## Proposal for **Supplement 2 to the 07 series of amendments to UN Regulation No. 107 (as adopted by GRSG at its 112 session)**

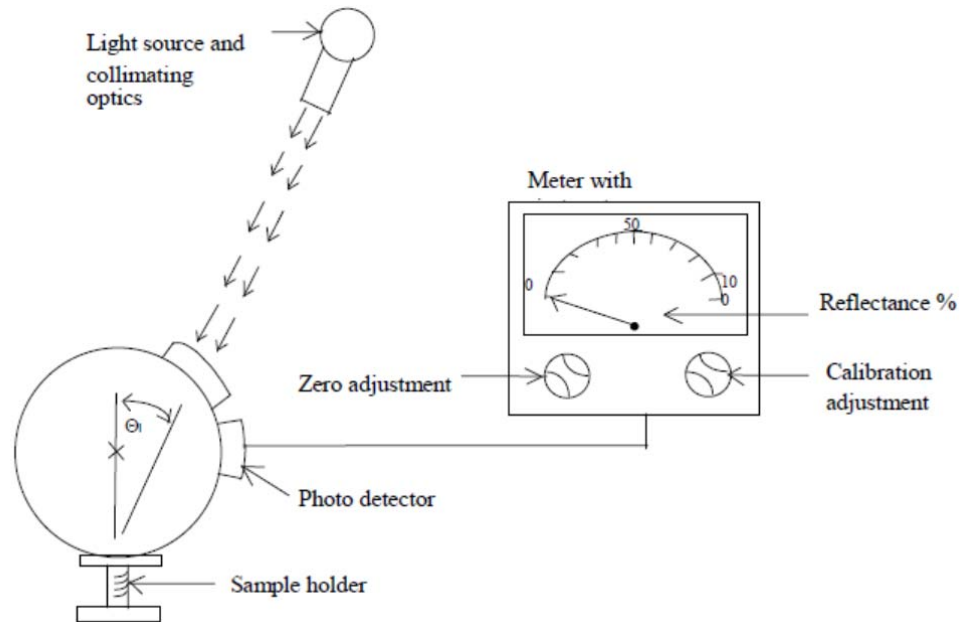
2. For determination of the reflectance values  $\rho_1$ ,  $\rho_2$  and  $\rho_d$  an integrating sphere according to CIE 38:1977 shall be used.

The reflectance shall be either read directly from the indicating instrument or calculated according to the following formula:

- 2.1. The illumination angle of the luminous flux of the incident light on the sample  $\Theta_i$  shall be equal to  $8^\circ \pm 0.5^\circ$ .
- 2.2. The luminous flux of the incident light on the sample shall be determined by using a diffuse reflectance standard calibrated by an accredited laboratory. The extended measurement uncertainty shall be lower than 3 per cent.
3. Example of an integrating sphere according to CIE 38:1977:
